**RE: Sonic – 98th & Bluewater
Conceptual Grading & Drainage Plan
Engineer's Stamp Date: No Date
Hydrology File: K09D048C**

Based upon the information provided in your submittal received 03/08/2023, the Conceptual Grading & Drainage Plan is preliminary approved for action by the Development Facilitation Team (DFT) on Site Plan for Building Permit.

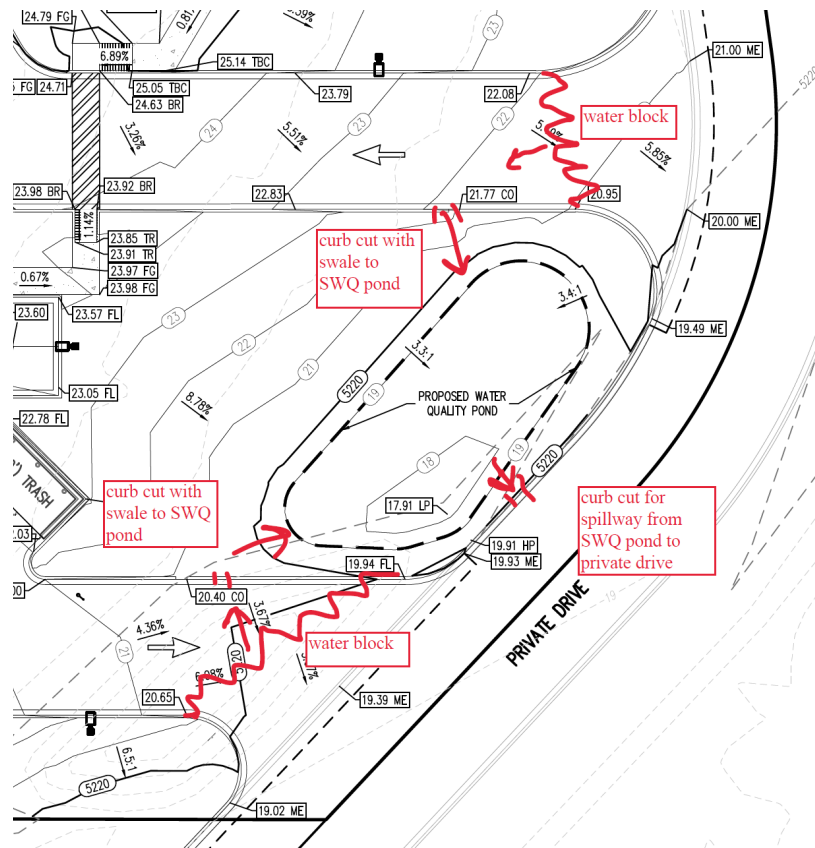
1. Please submit a more detailed Grading & Drainage Plan to Hydrology for review and approval. This digital (.pdf) is emailed to PLNDRS@cabq.gov along with the Drainage Transportation Information Sheet.
2. Please provide a water block at the two entrances from the private drive and provide curb cuts and swales for the drainage to go into the proposed stormwater quality pond and one on the east side of the stormwater quality pond for the spillway. See below.
